TAL-CO SUPPLEMENTAL INSTRUCTION #02-R1			
Project Name:	RW TOMLINSON - NEW HEAD OFFICE		
Project Location:	100 Nortel Drive, Ottawa, Ontario		
ARCH. SI #:	A-111 (9,2,2016), ASK-1	Issued By:	Chris Simpson
STRUC. SI #:	SSI #2	Date Issued:	October 21, 2016
MECH. SI #:	Sump Pit Section	Revision #:	N/A
ELEC. SI #:	N/A	Revision Date:	N/A

Title: Revision to sump pit depth

STRUCTURAL SITE INSTRUCTION No.: 002

SSI-SQ-SK1

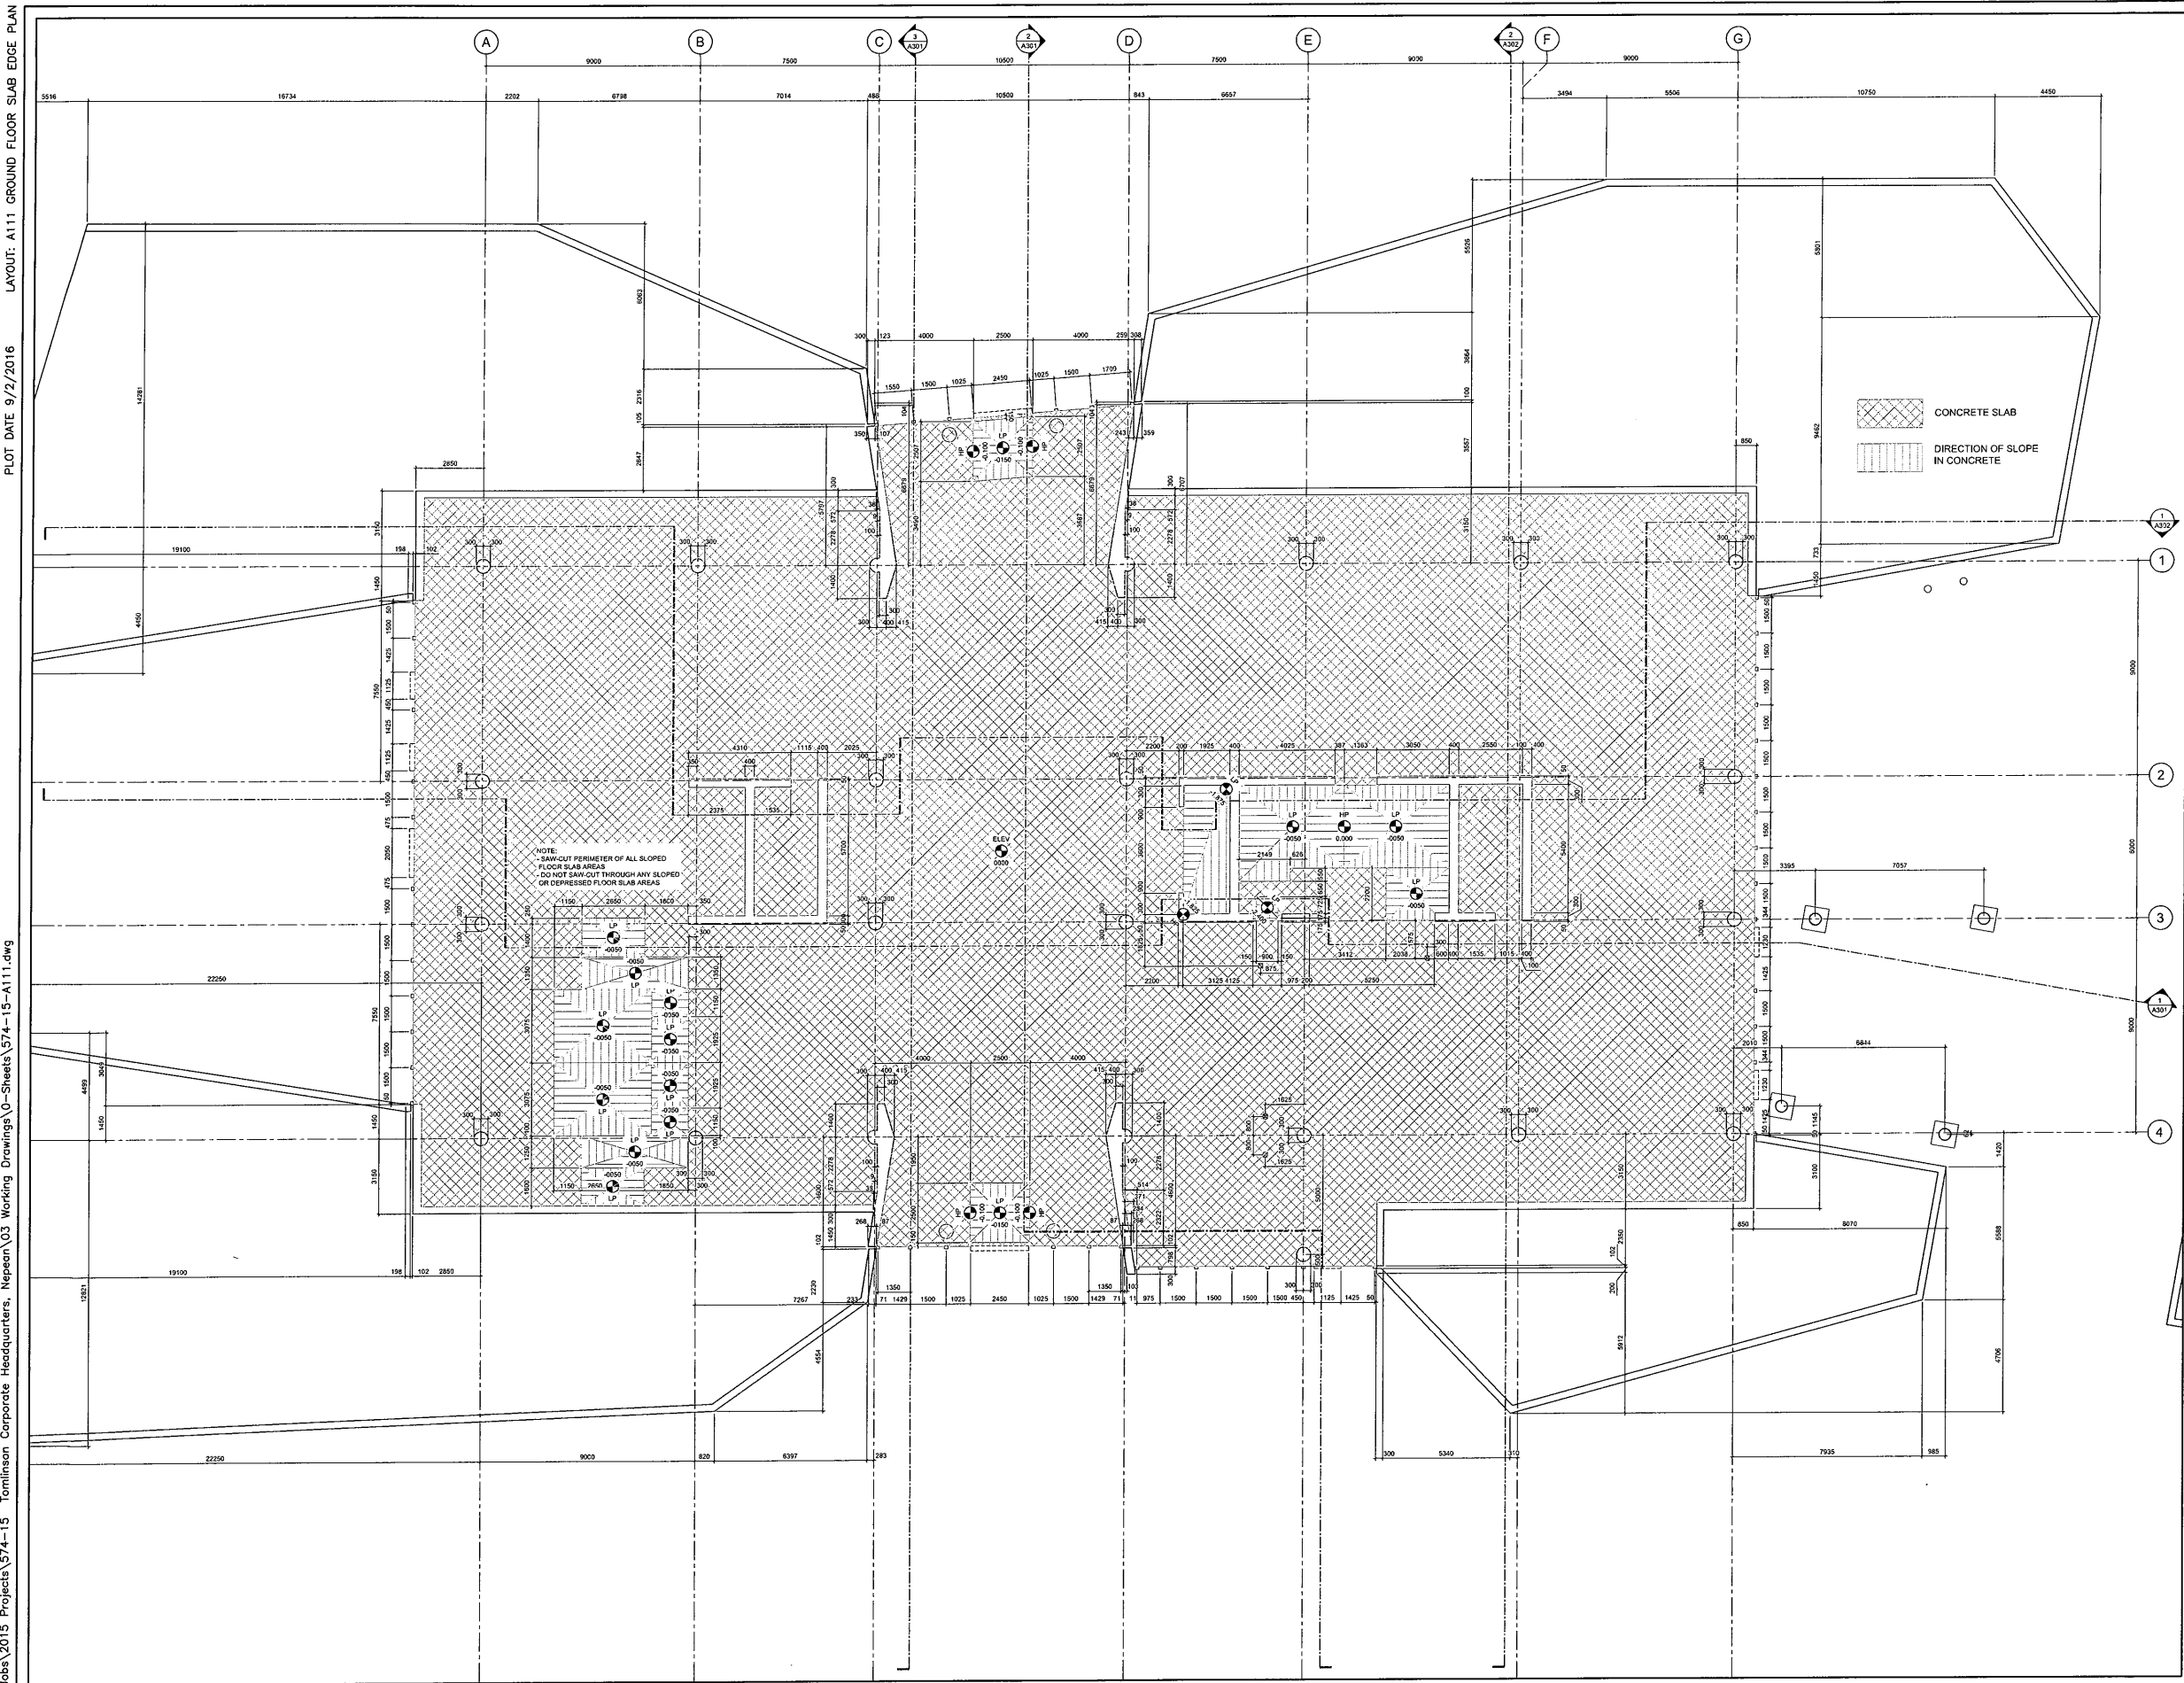
Information to be Clarified: Reinforcing Steel in Footing around Sump Pit

Provide the reinforcing modifications as noted on the partial plan in SSI-S2-SK1.

ELEVATOR PIT TO NOTCH TOP OF FTG BY 1400mm.

1
 GROUND FLOOR SLAB EDGE PLAN
 SCALE: 1/100

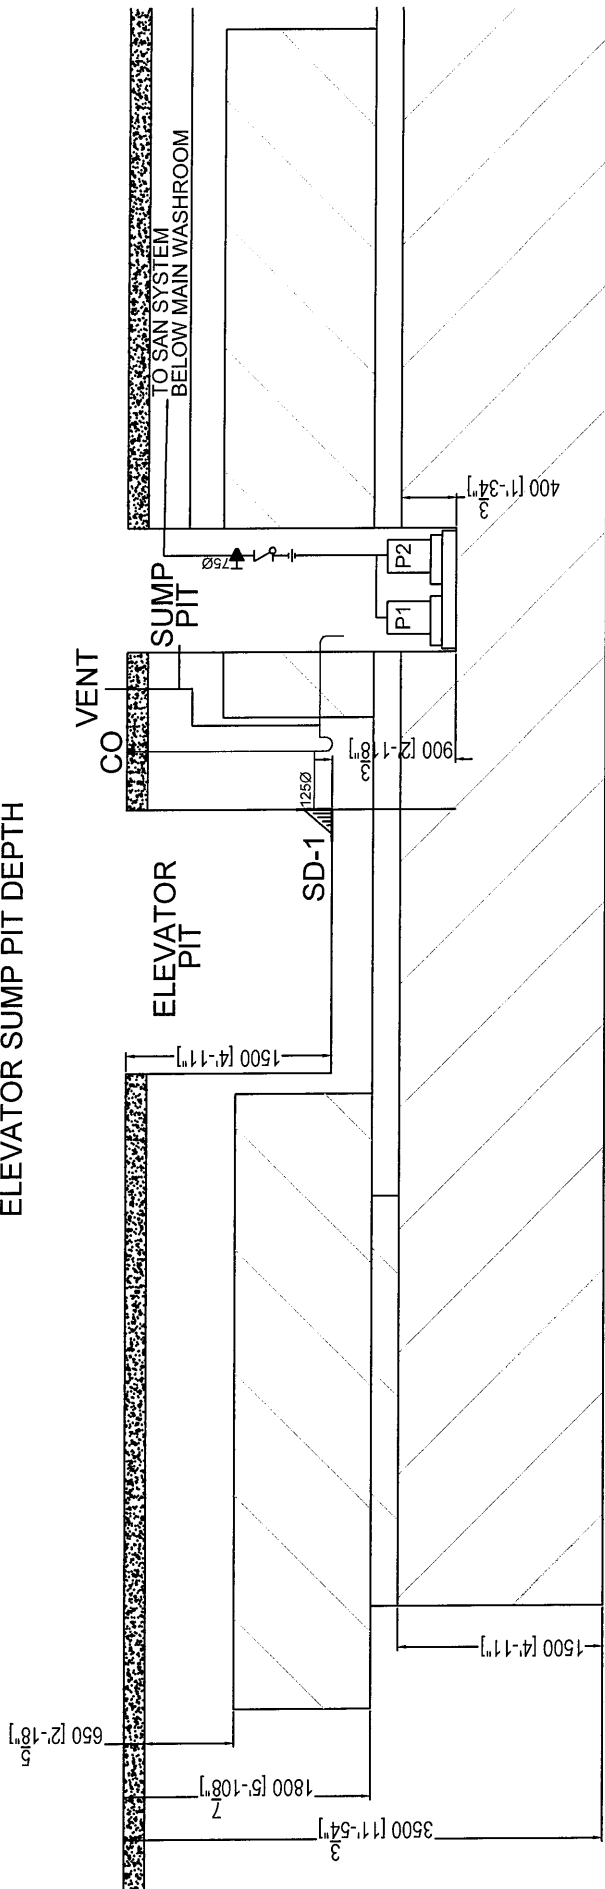
Description of the Work: Position sump pit as per revised architectural slab edge drawing, additional reinforcing required to recess pit into footing pad. **Revised sump pit frame and cover details.**

17 SUMP PIT COVER DETAIL

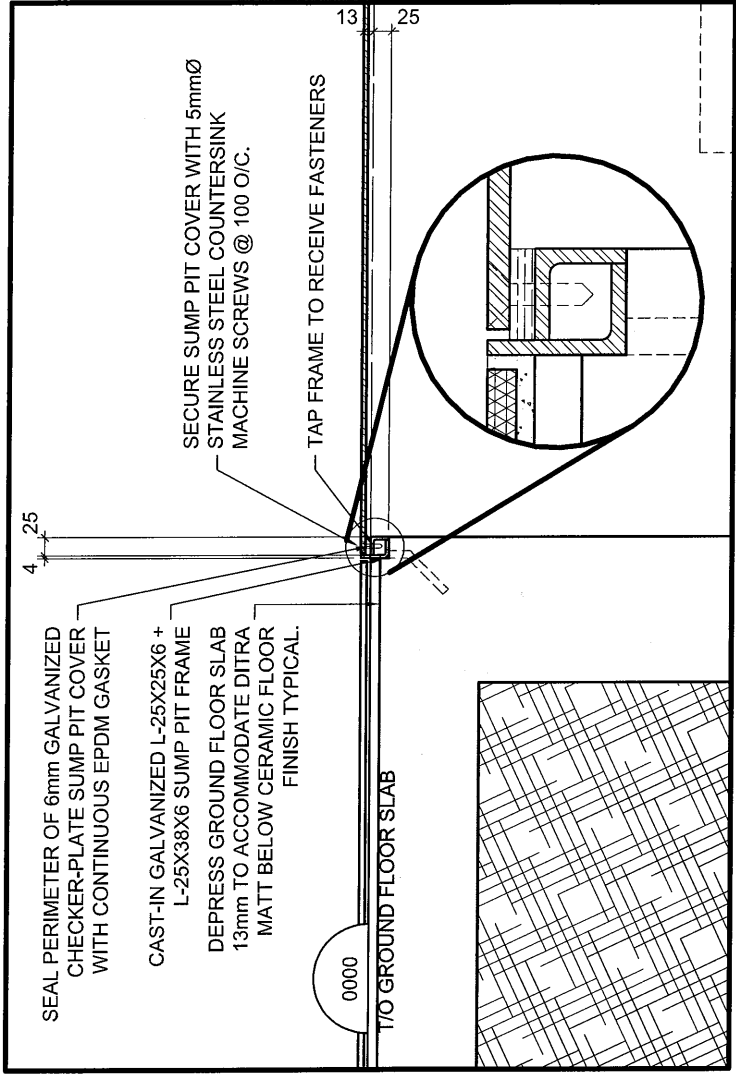
SEAL PERIMETER OF 6mm GALVANIZED CHECKER-PLATE SUMP PIT COVER WITH CONTINUOUS EPDM GASKET

CAST-IN GALVANIZED L-25X25X6 + L-25X38X6 SUMP PIT FRAME

DEPRESS GROUND FLOOR SLAB 13mm TO ACCOMMODATE DITRA MATT BELOW CERAMIC FLOOR FINISH TYPICAL.

SECURE SUMP PIT COVER WITH 5mmØ STAINLESS STEEL COUNTERSINK MACHINE SCREWS @ 100 O/C.

TAP FRAME TO RECEIVE FASTENERS
